Cactus Basin Specifications & Change Orders

Specifications
&
Contract Documents
For
PVSP DRAINAGE SYSTEM

PROJECT #8916
BID CALL 84-86

PVSP DRAINAGE SYSTEM #8916 CHANGE ORDER #10

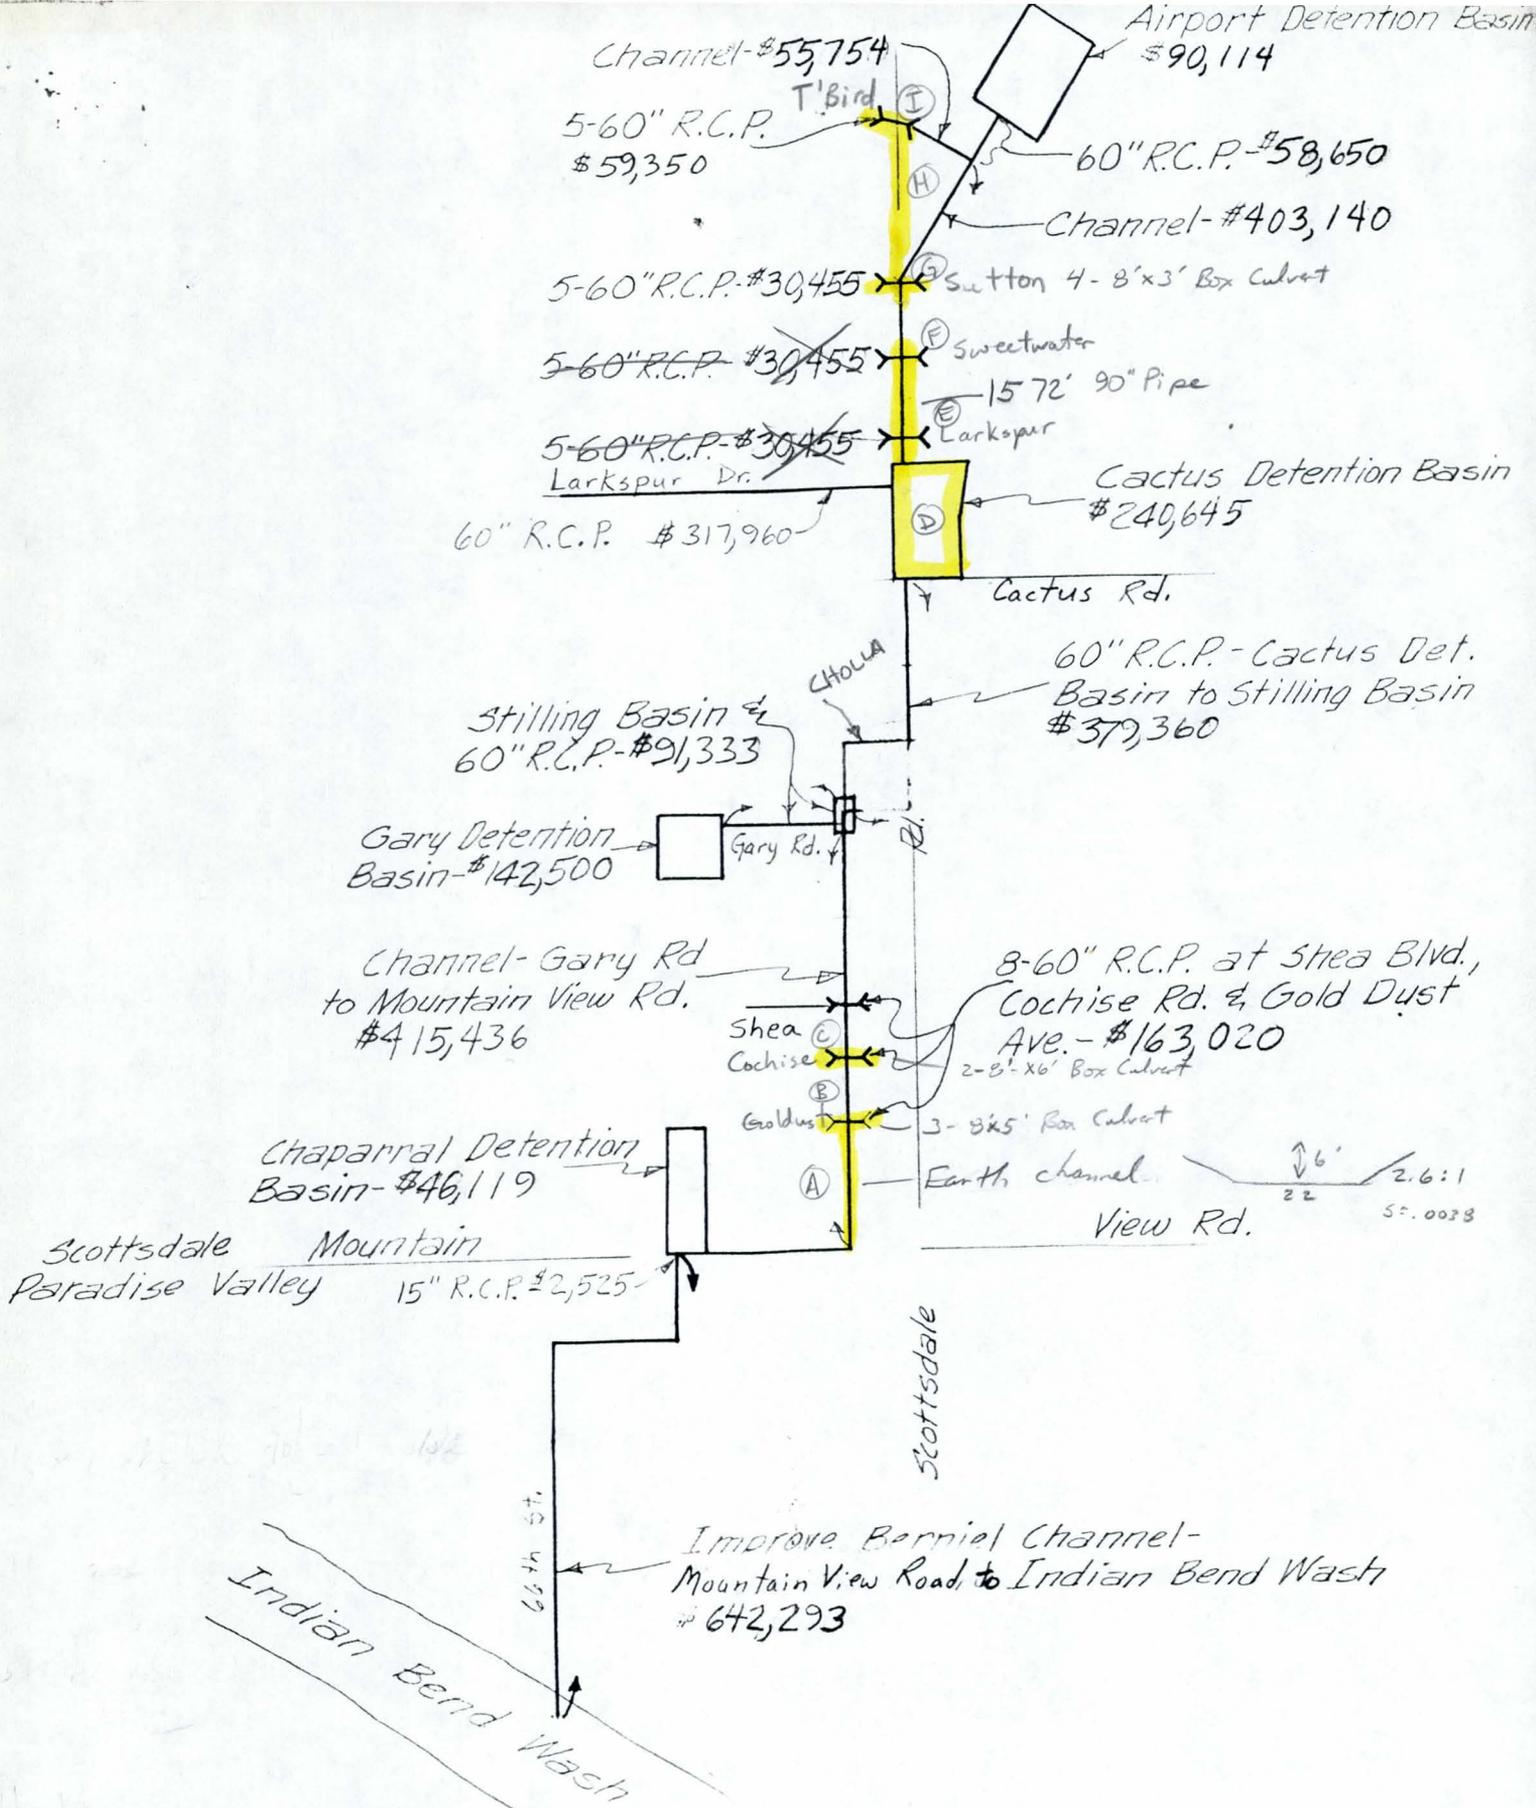
1. Saw cut 1-foot notch in precast concrete curb and grade 'V' ditch 30 feet to match existing ditch at Sta 10+80 on Gold Dust. See attached drawing.

Constr. 170 L.F. Precast 6" Curb, See Detail Right

Provide drainage outlet and swale to drain ponding area on Golddust and installation of sewer drop connecting at Fire Station, per Water Resource's Engineering request.

The concrete curb notch and drainage swale will drain a ponding area on Golddust to an existing drainage ditch. The drop connection at the new sewer tap was required by the City's Sewer Engineering Department.

HEADWALL AT SUTTON DRIVE

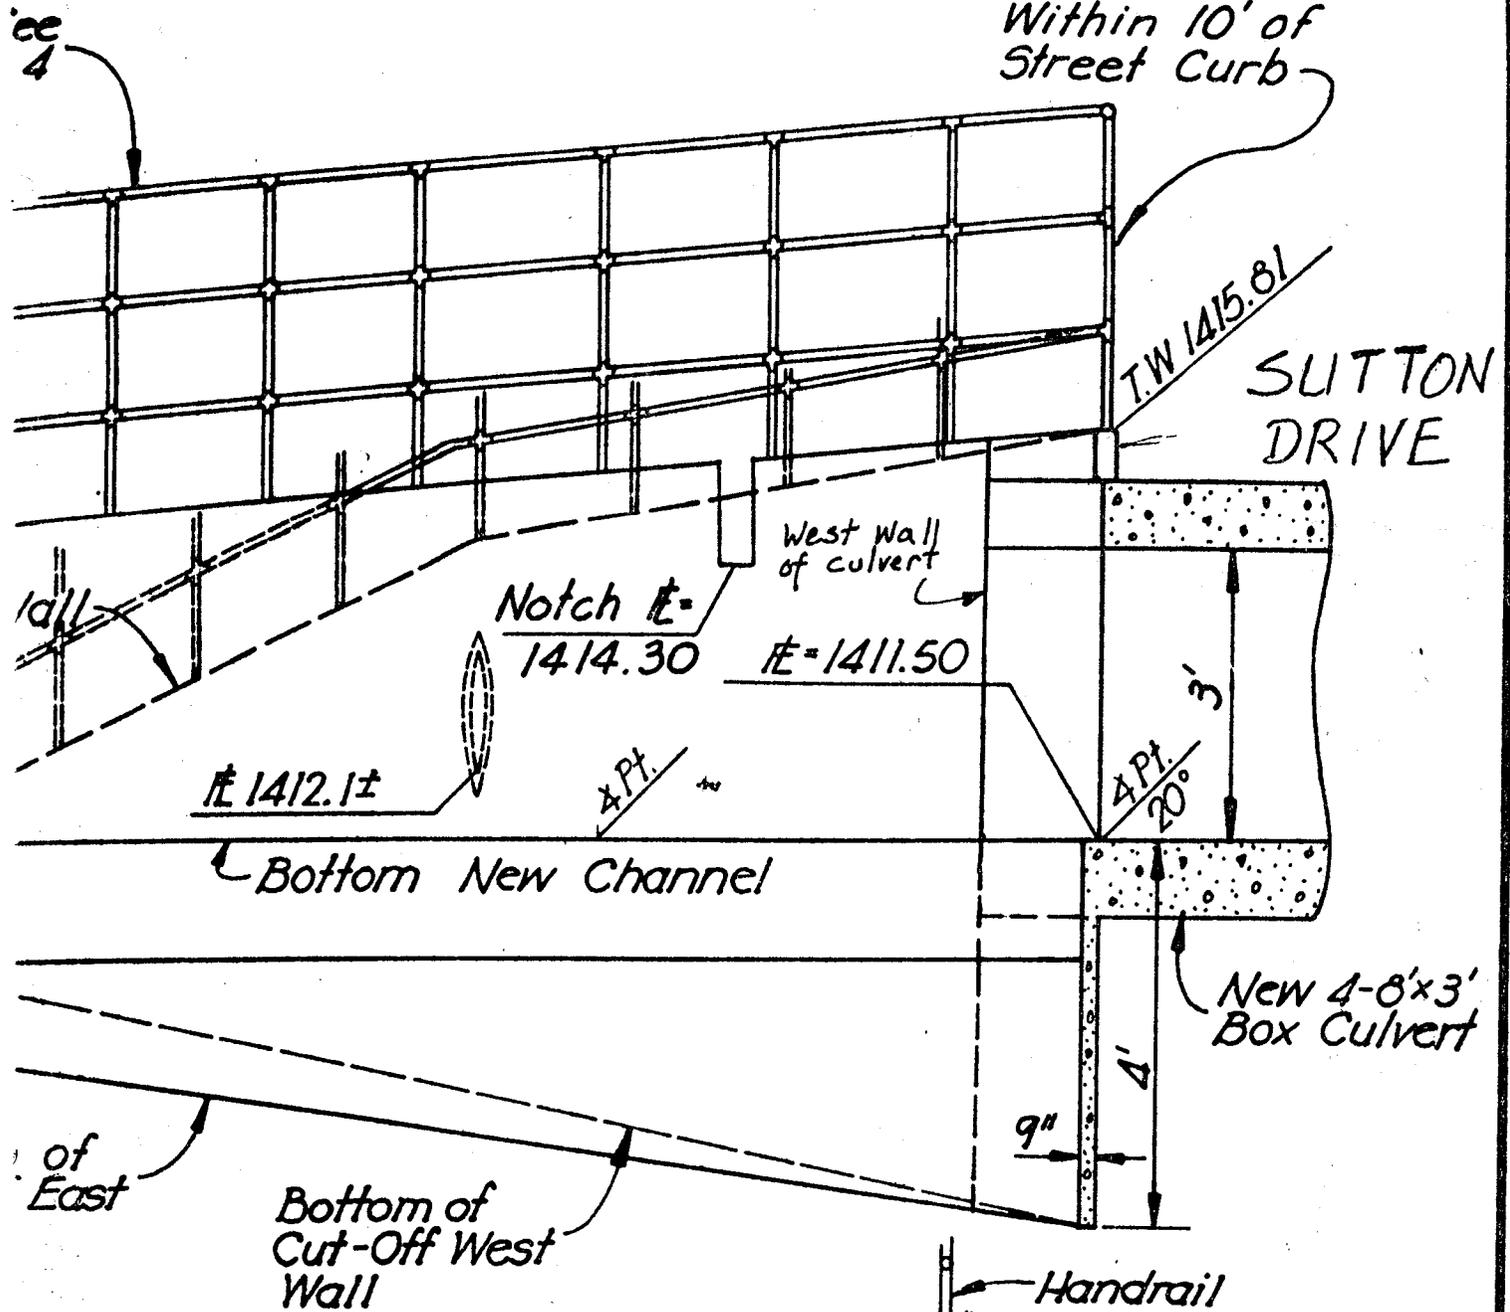
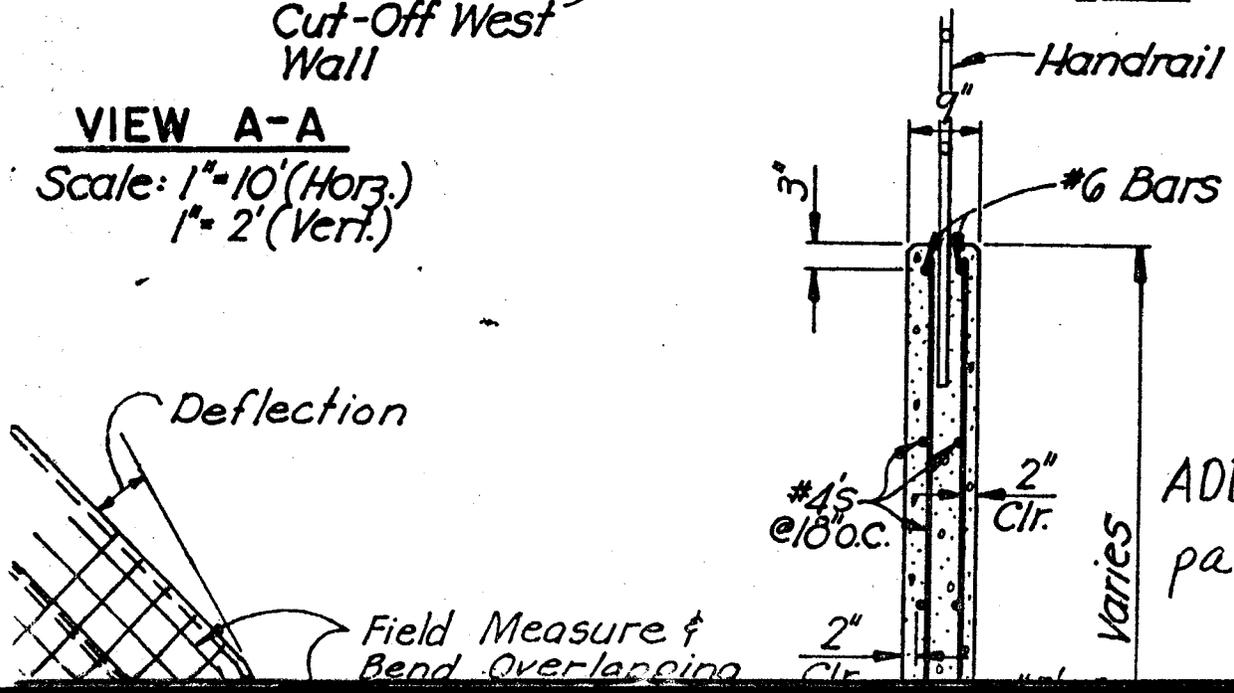
<u>SHEET #</u>	<u>CHANGE</u>
2	Extended west barrel of box culvert as shown on Page 5 and 6 of this addendum.
16	Added clarification of manhole shaft (Std. Det. 522), water tight manhole cover (Std. Det. 523) and added manhole steps (Std. Det. 428) inside of culvert wall as shown on page 7 of this addendum.
28-30	Enclosed drawings should be attached as part of the plan set. Plan sets picked up from the City of Scottsdale, Purchasing Office, after May 24, 1984, have these sheets included. Add Note: Signal to be manually controlled by Scottsdale Police Department during construction hours, when deemed necessary by the inspector.
31	Enclosed drawing should be attached as part of the plan set. Plan sets picked up from the City of Scottsdale, Purchasing Office, after May 24, 1984, have this sheet included.
31	Additional details of chain link fence grate for 90° outlet structure as shown on Page 8 and 9 of this addendum.

Handrail A.D.O.T.
Detail B-22.30
Within 10' of
Street Curb

Addendum No. 2
Page 2

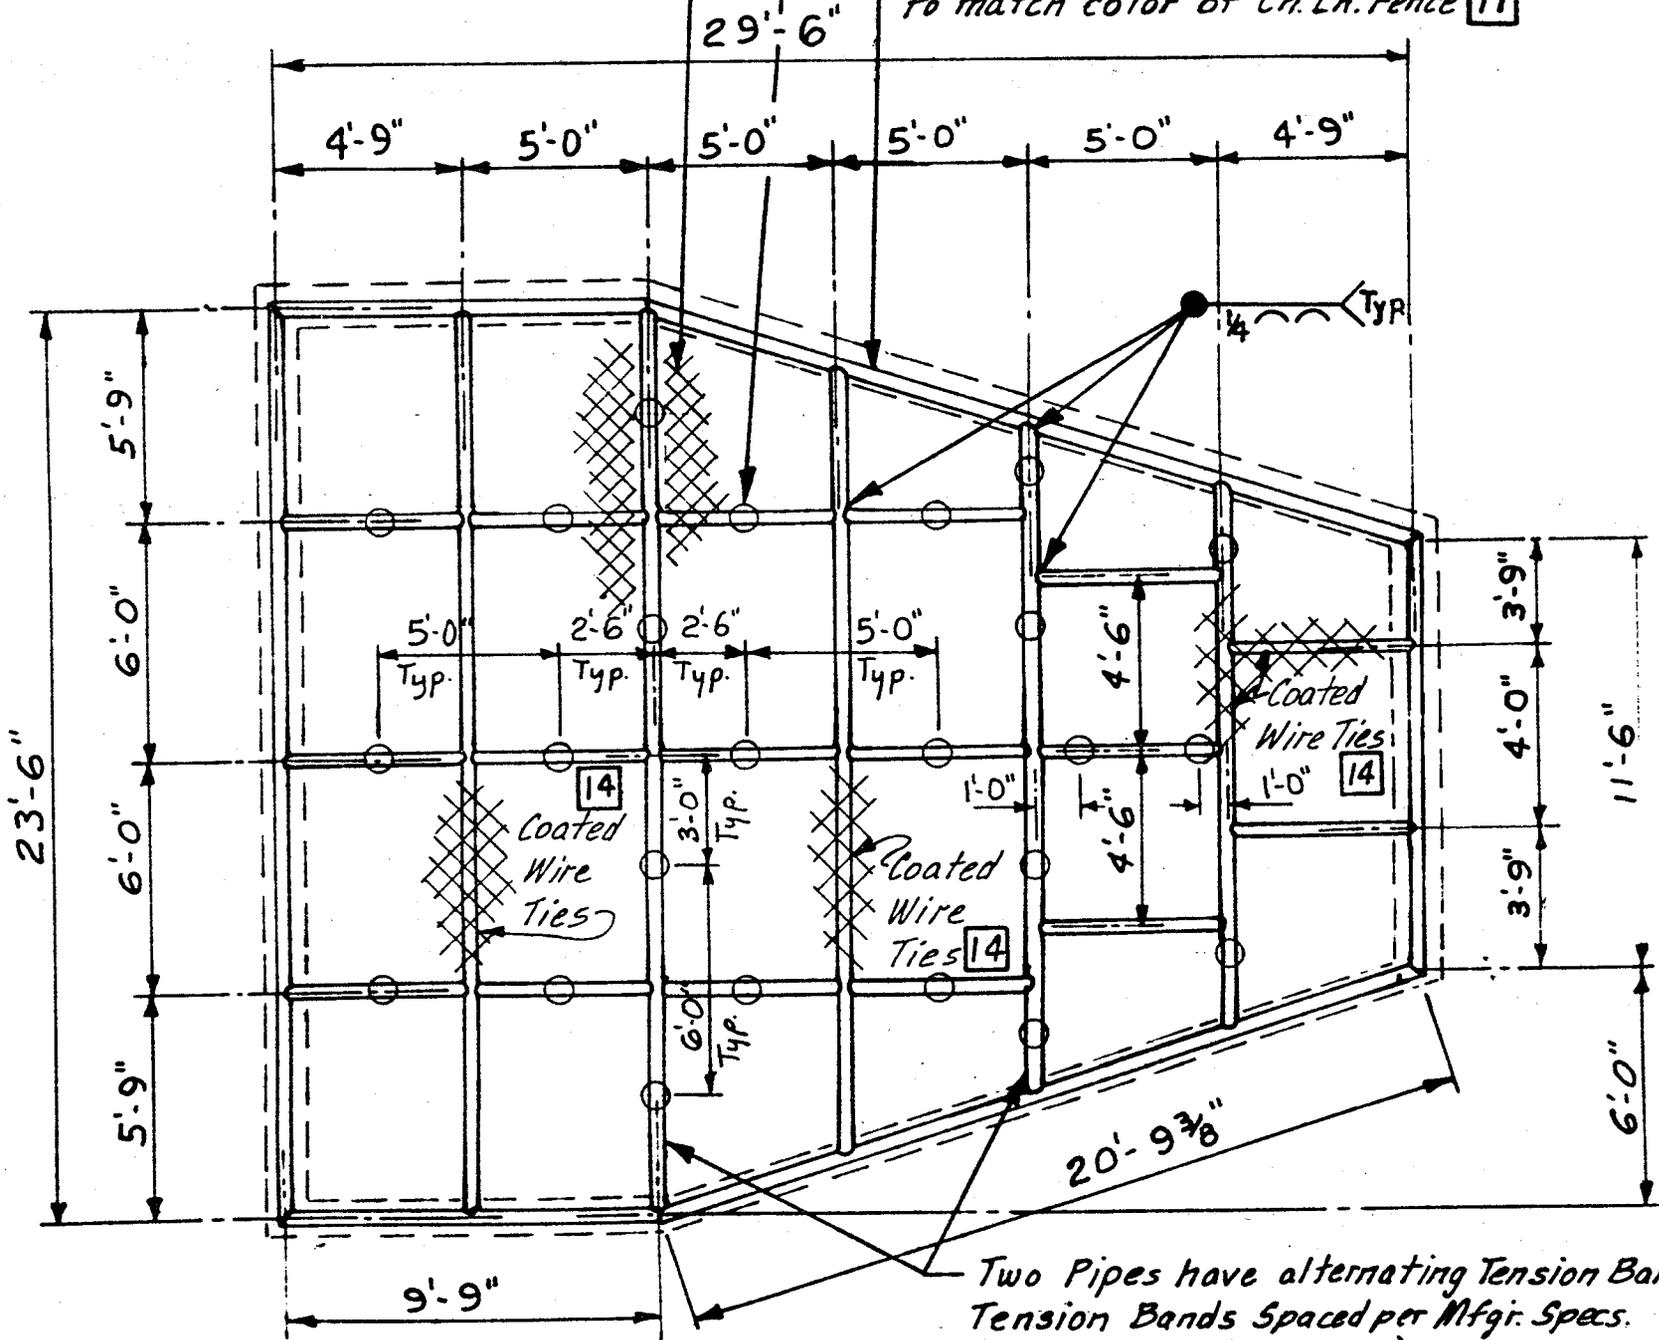
<u>Sheet #</u>	<u>Change</u>
14	Change note describing handrail on south side of Sutton that reads, "Install 170 LF Triple Rail Handrail ADOT Detail B-22.30 on Box Culvert Curb and Wing Walls," to "Install 170 LF Triple Rail Handrail on Box Culvert Curb and Wing Walls, See Detail Sheet #4."
31	Replace Page 8 of Addendum No. 1 with this detail, as shown on Page 2 of this Addendum.

13 9 Ga. x 2" x 10' Wide Dura-Bond or equal Chain Link Fence

All pipe to be min. 2 1/2" I.D. Galv. H.W. Pipe. To be painted to match color of Ch. Lk. Fence 11

PVSP DRAINAGE SYSTEM
CHANGE ORDER NO. 3
ATTACHMENT No. 3B

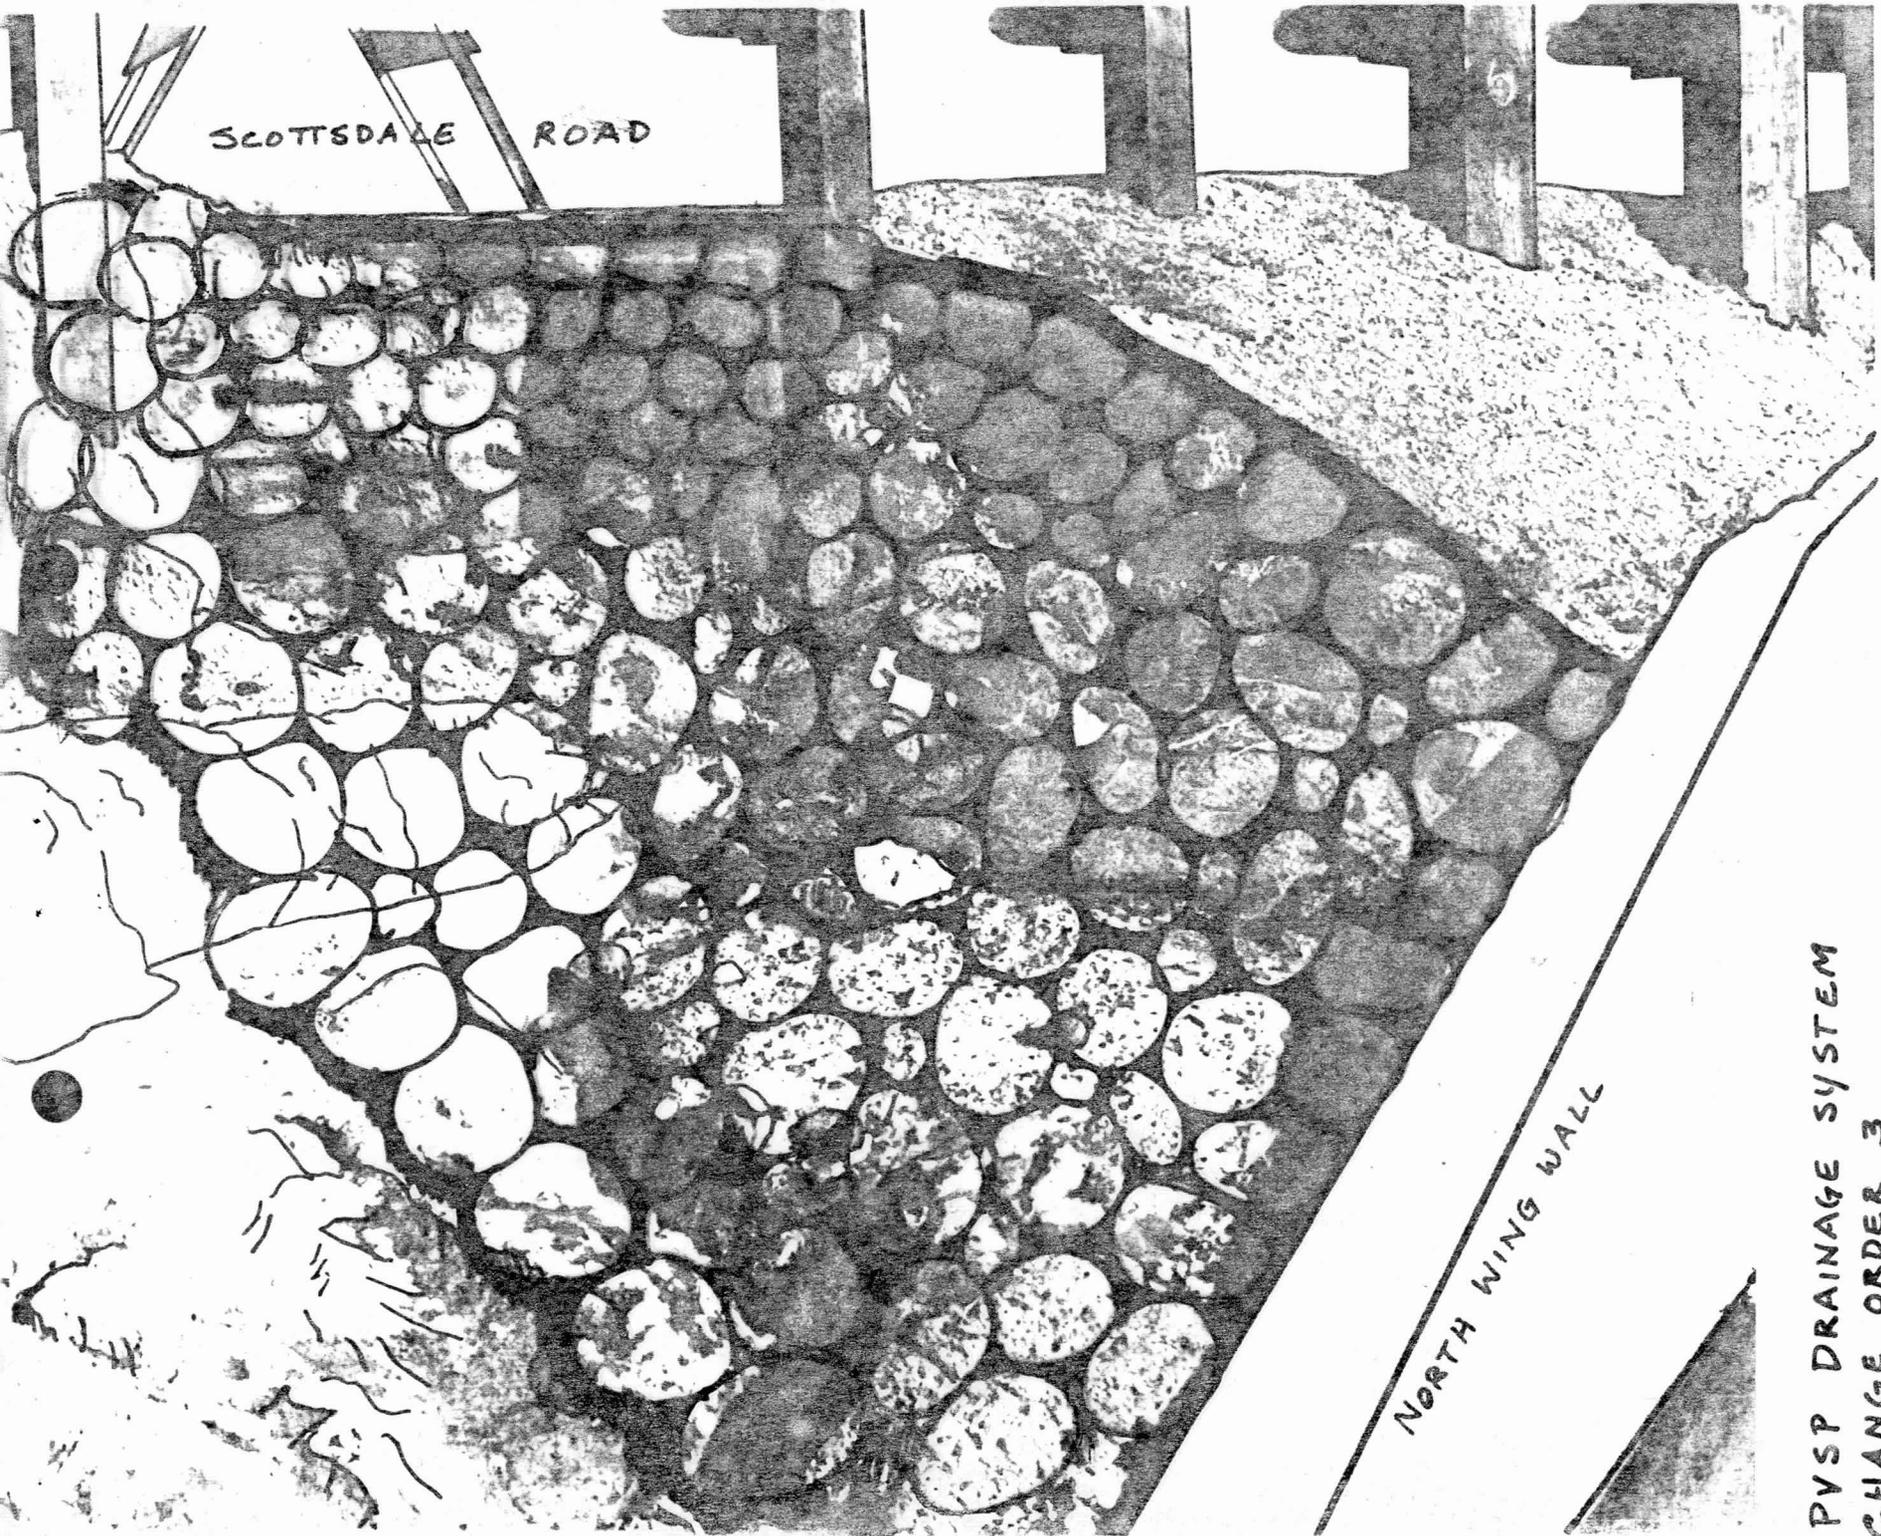
NORTH WING WALL

SOUTH WING WALL
